**U.S. ENVIRONMENTAL PROTECTION AGENCY
TECHNICAL ENFORCEMENT SUPPORT
AT
HAZARDOUS WASTE SITES**

**FINAL RCRA TECHNICAL
ASSESSMENT REPORT
OF THE
COLLIS, INC. FACILITY
CLINTON, IOWA
EPA I.D. NO. IAD047303771**

**JACOBS ENGINEERING GROUP, INC.
5301 CENTRAL AVENUE, N.E., SUITE 1600
ALBUQUERQUE, NEW MEXICO 87108
(505) 262-1505
JACOBS PROJECT NO. 05-B846-00**

**DRAFT: SEPTEMBER 30, 1988
FINAL: DECEMBER 7, 1988**

Figure 2. Monitoring Well Locations - Collis, Inc.

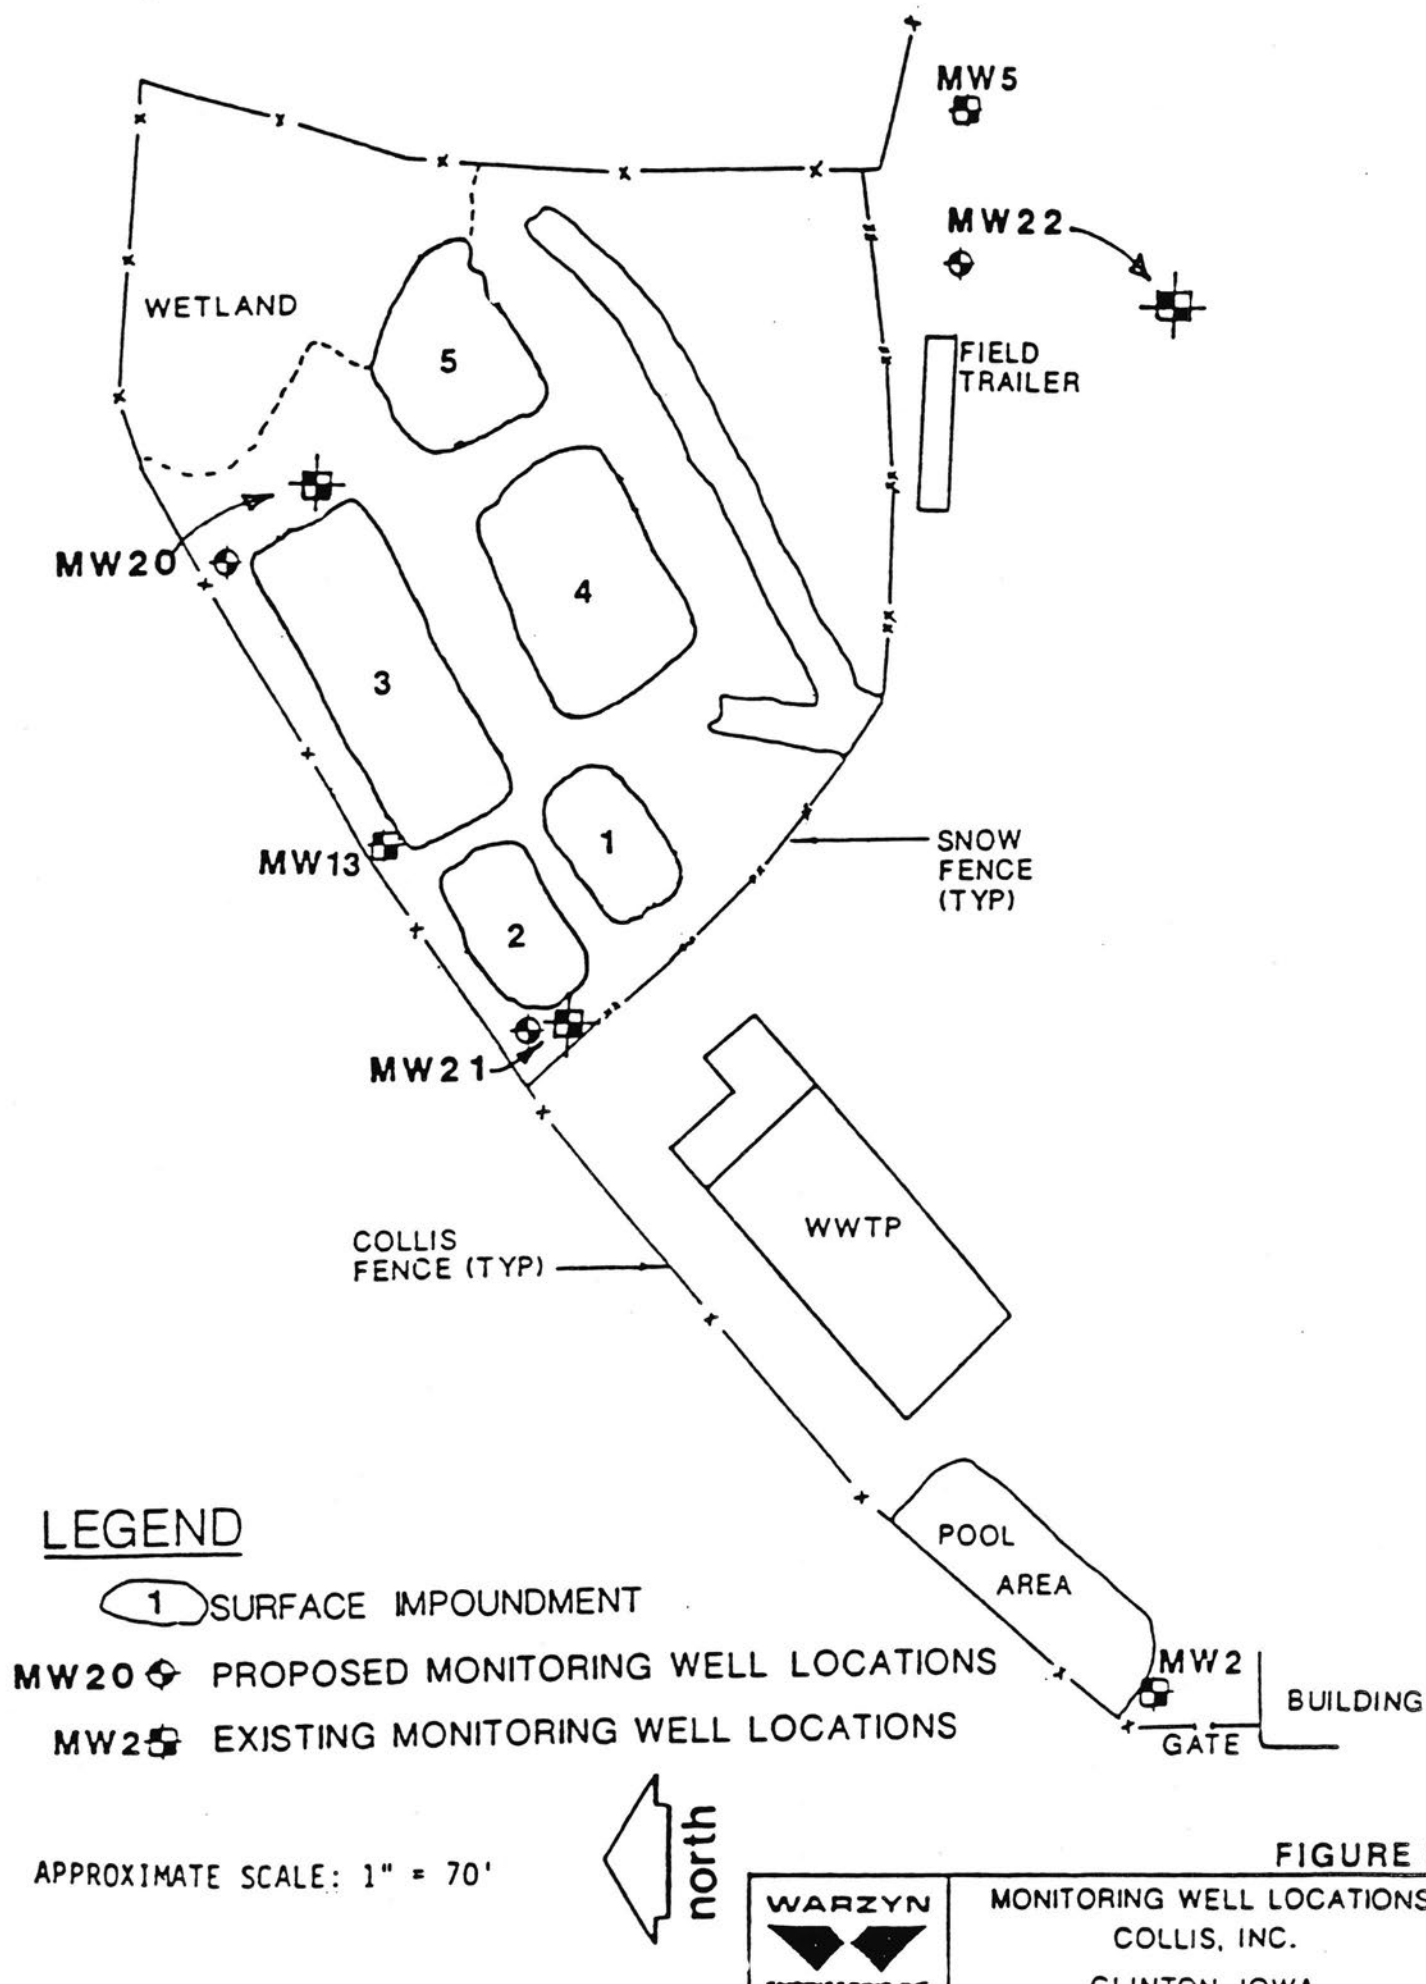
number of downgradient detection monitoring wells is marginal although it meets the minimum requirements of 40 CFR 265.91. The actual locations of wells MW-20 and MW-21 (see Figure 2) as determined during the Jacobs QA/QC audit were different than the proposed location indicated on Figure 2.

The placement of the upgradient monitoring well (MW-22) is adequate to yield groundwater samples that are representative of background groundwater quality in the upper saturated soil/fill soils (and part of the limestone rubble) near the waste management area although it is distant from the surface impoundments. No explanation was provided concerning the location of the well and its screen length. In addition, it is difficult to determine if the well was screened in the same portion of the soil/fill horizon as the downgradient monitoring wells because of the presence of a buried channel beneath the impoundments and due to the fact that the uppermost aquifer was not defined. The actual location of well MW-22 (see Figure 2) as determined during the Jacobs field audit was different than the proposed location.
